**THE  
NATIONAL  
BOARD**  
OF BOILER AND  
PRESSURE VESSEL  
INSPECTORS

# **NATIONAL BOARD SUBCOMMITTEE INSTALLATION**

## **MINUTES**

Meeting of July 20th, 2016  
Columbus, OH

**FIGURE 3.7.5.1-a**  
STEAM BOILERS IN BATTERY — PUMPED RETURN — ACCEPTABLE PIPING INSTALLATION

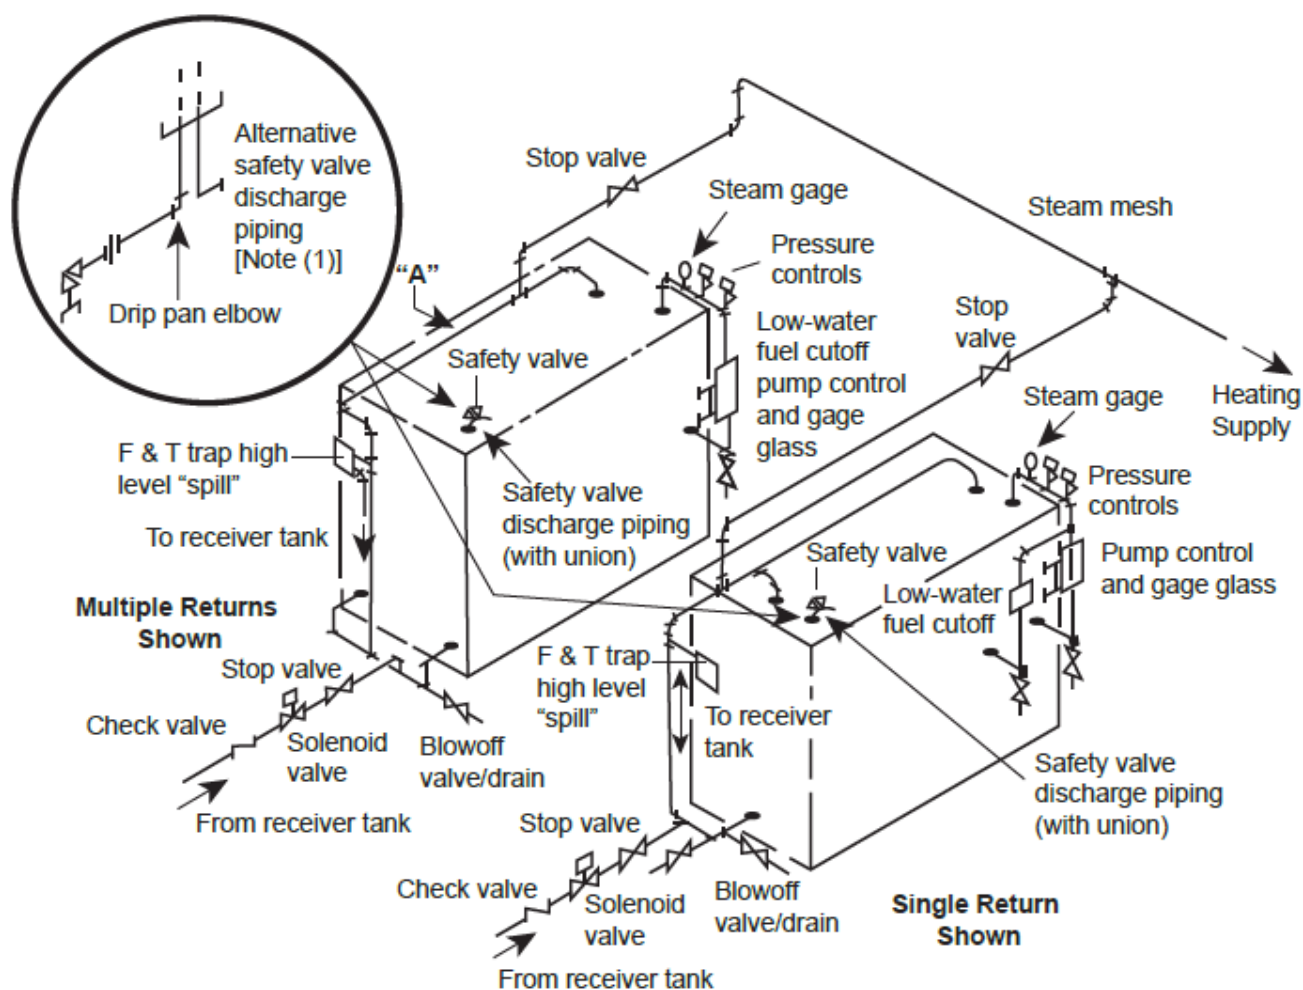
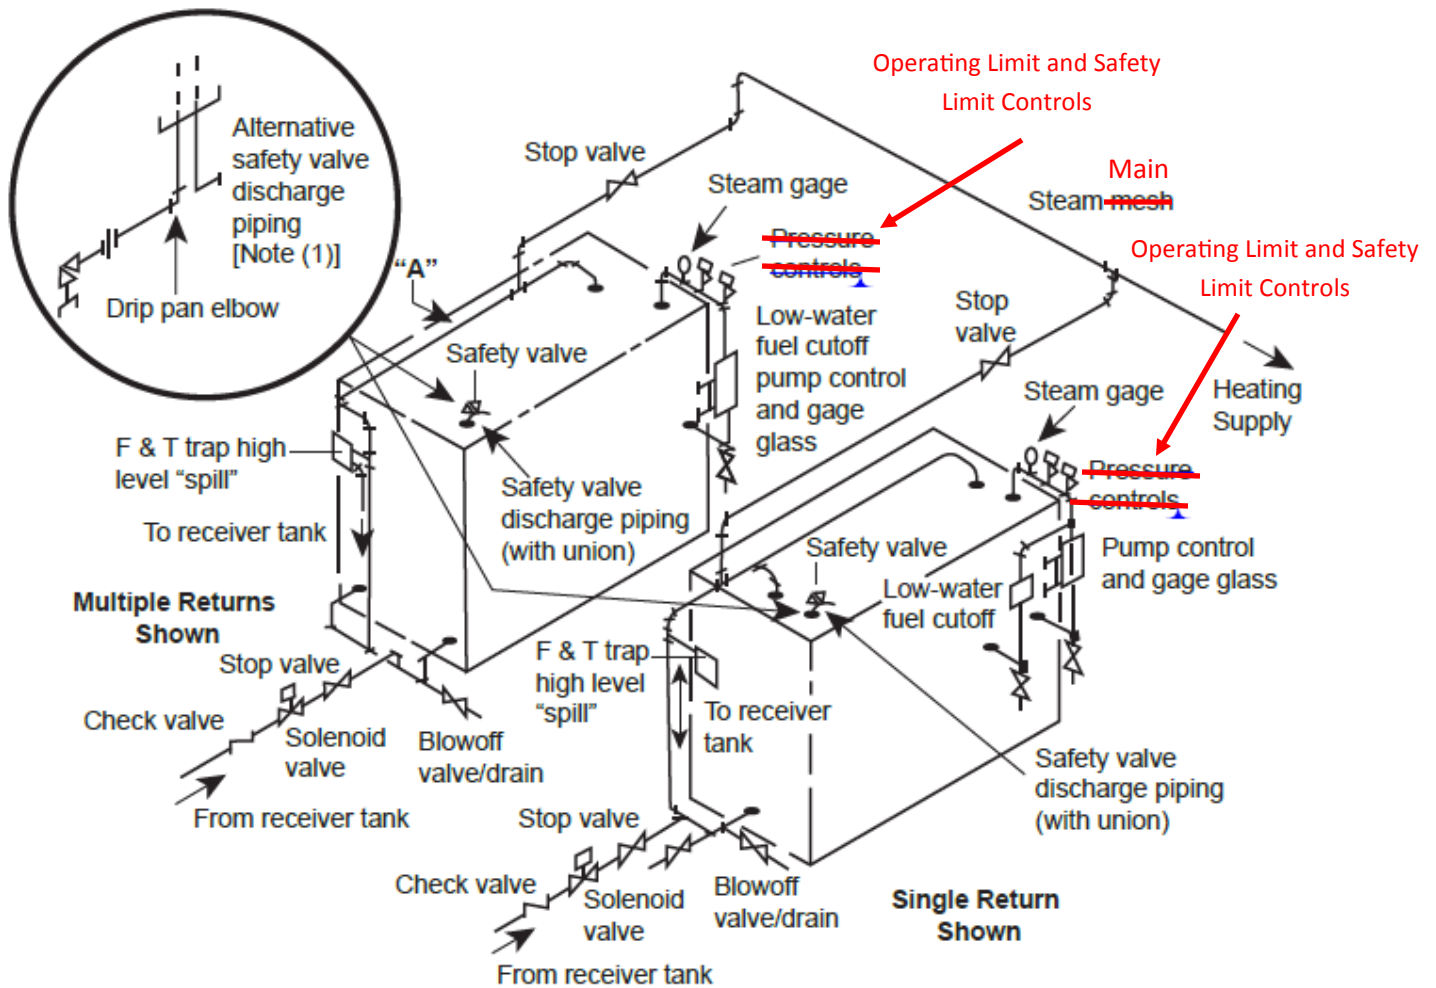
<b>Item Number: NB15-0106</b>	<b>NBIC Location: Part 1, 3.7.5.1</b>	<b>Attachment Pages 2-7</b>
<b>General Description:</b> Address Figure 3.7.5.1		
<b>Subgroup:</b> Installation		
<b>Task Group:</b> B. Moore (PM), T. Creacy, M. Washington, and <u>R. Austin</u>		
<b>Meeting Action:</b> Add R. Austin to the TG. In the SG meeting a working group met to discuss and prepare a proposal of editorial changes to figures 3.7.5.1 a, b, and c with regard to pressure controls (operating and high limit). The SG unanimously approved the proposal to the SC. The SC makes a motion to approve the proposal to the MC. The motion was unanimously approved.

# Proposed Changes

**FIGURE 3.7.5.1-b**  
STEAM BOILERS IN BATTERY — GRAVITY RETURN — ACCEPTABLE PIPING INSTALLATION

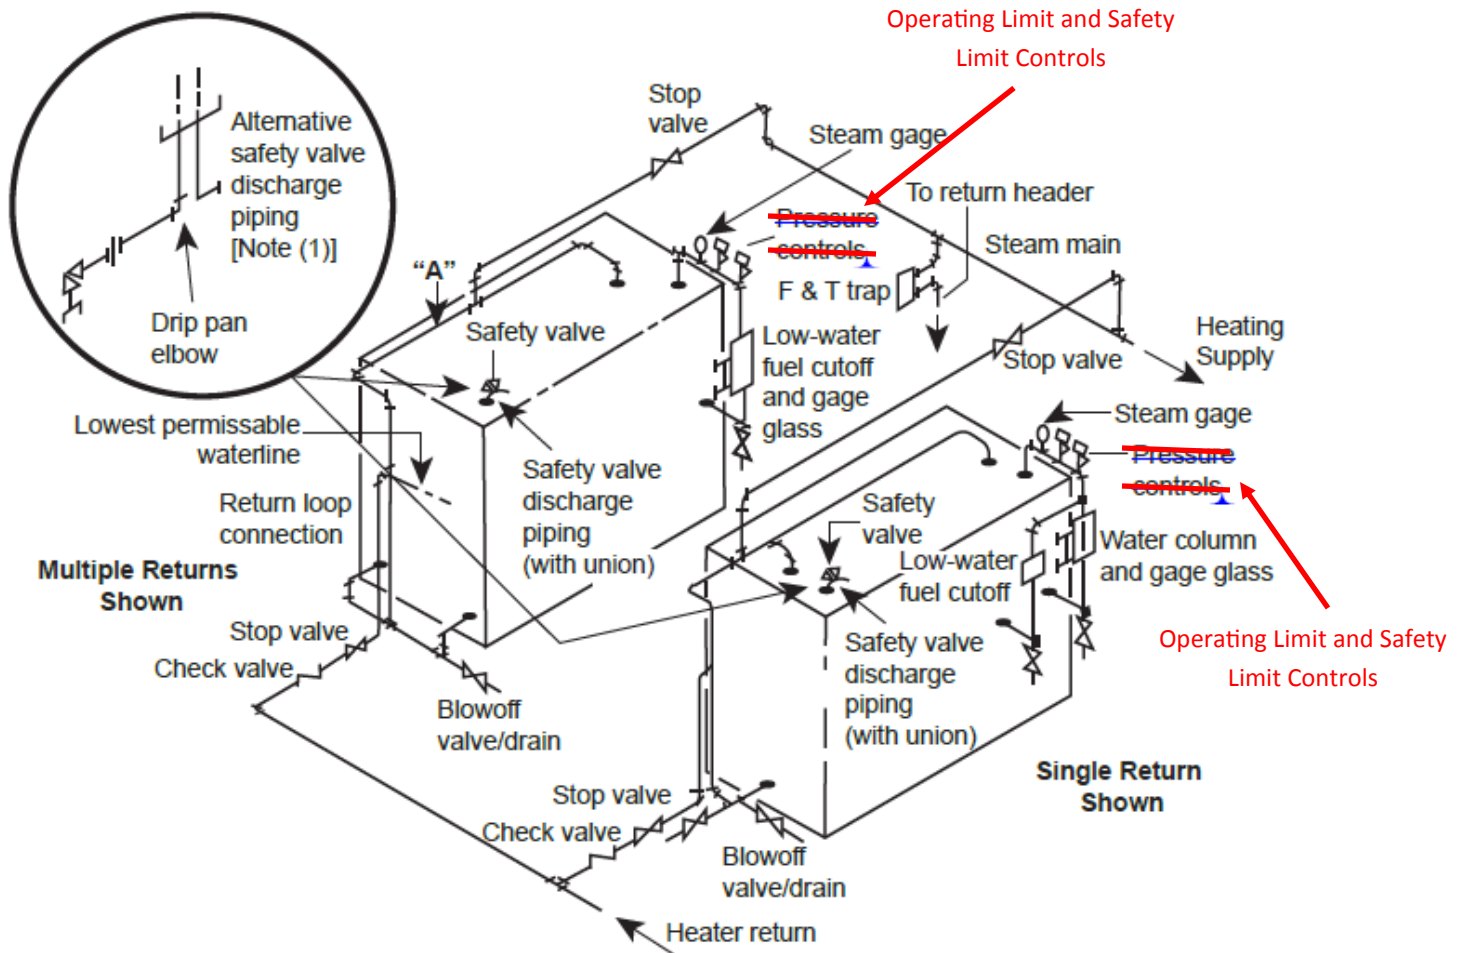
# Proposed Changes

**FIGURE 3.7.5.1-c**  
HOT-WATER BOILERS IN BATTERY — ACCEPTABLE PIPING INSTALLATION

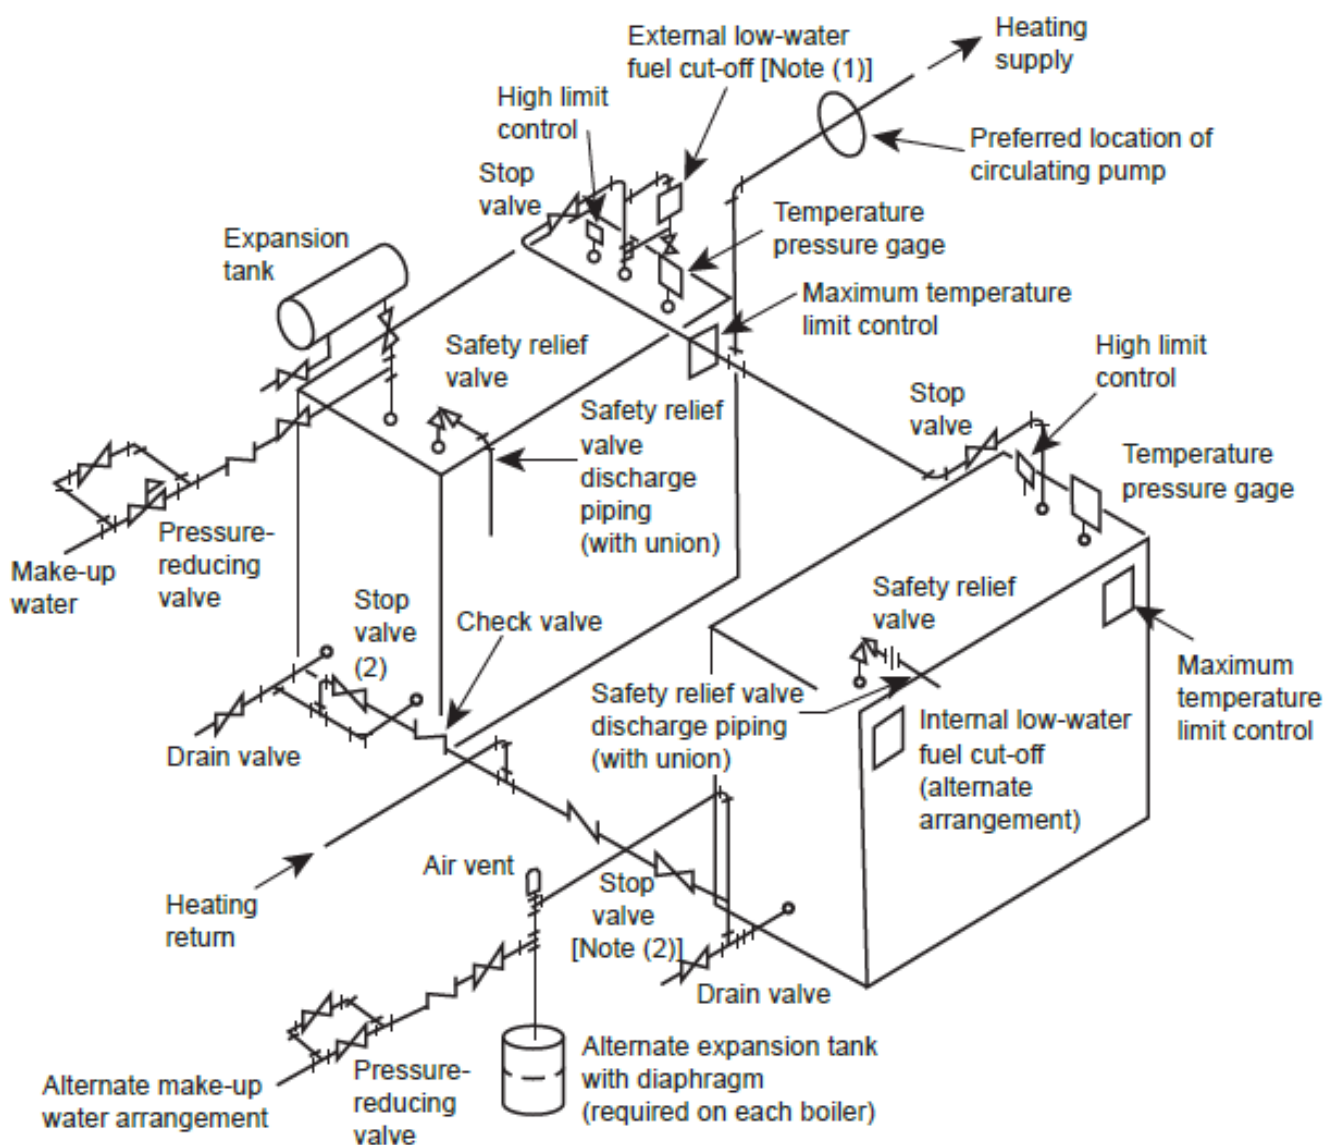
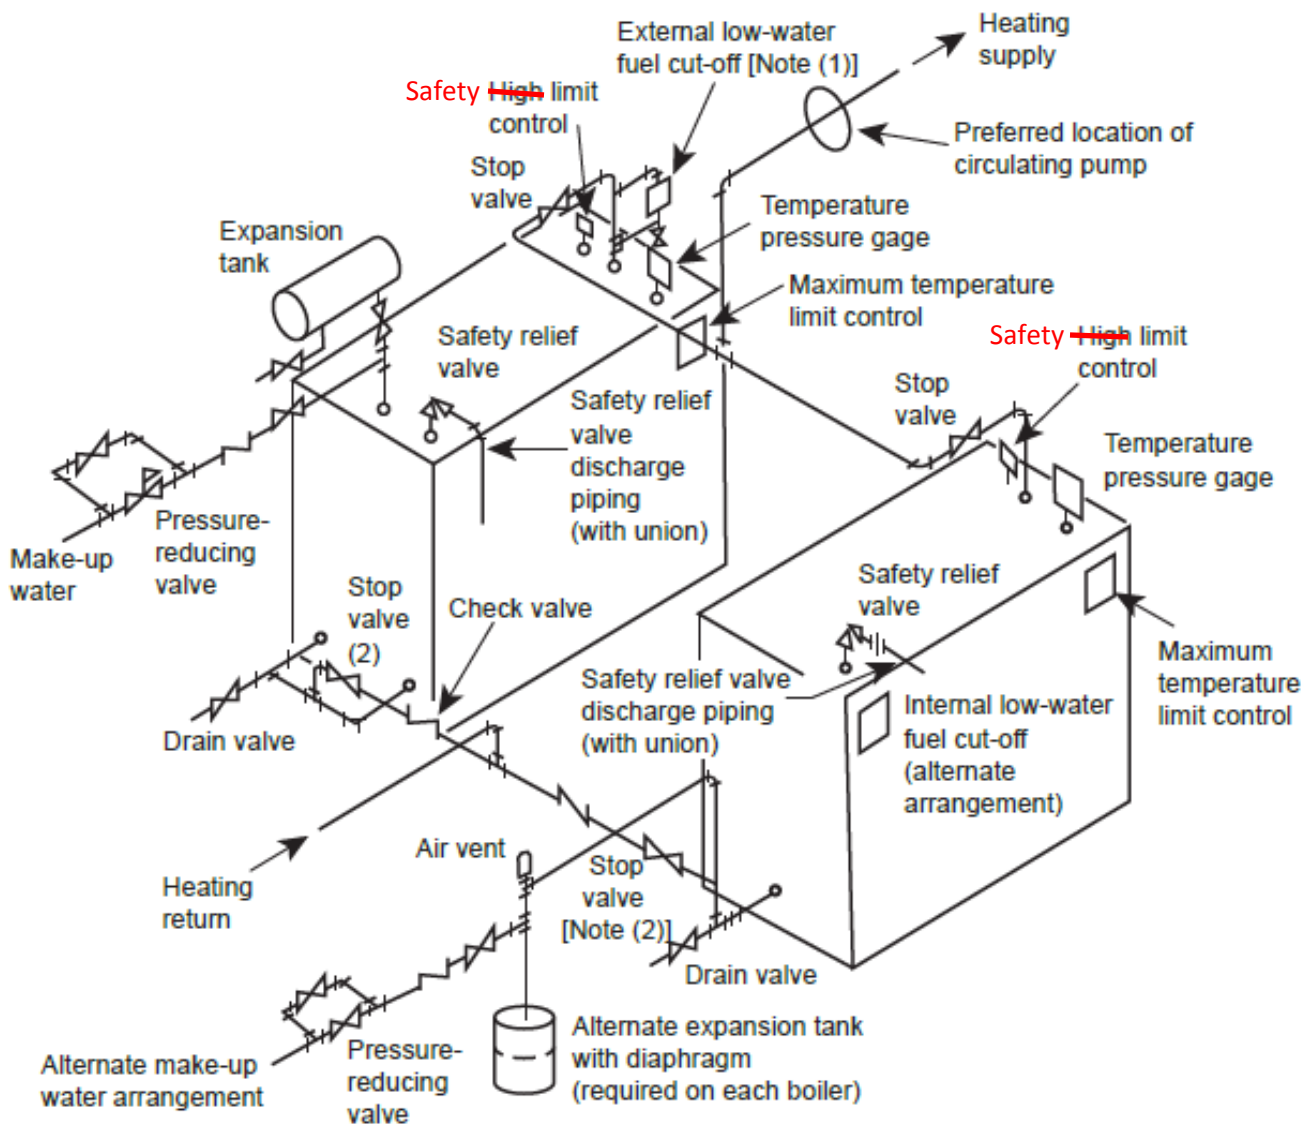
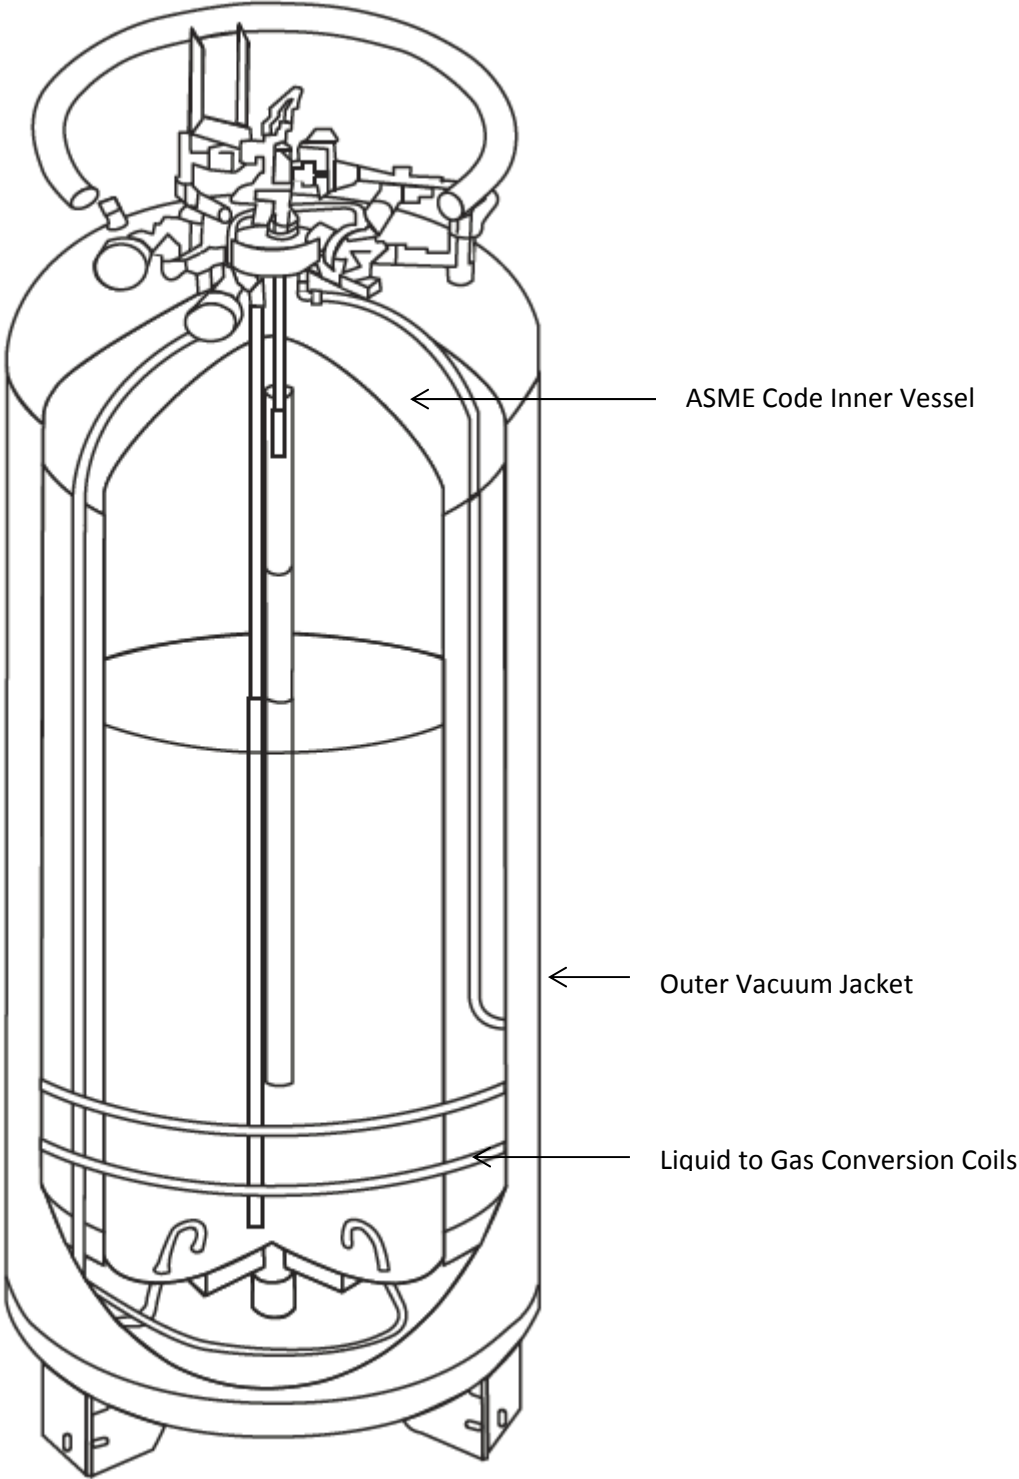
# Proposed Changes
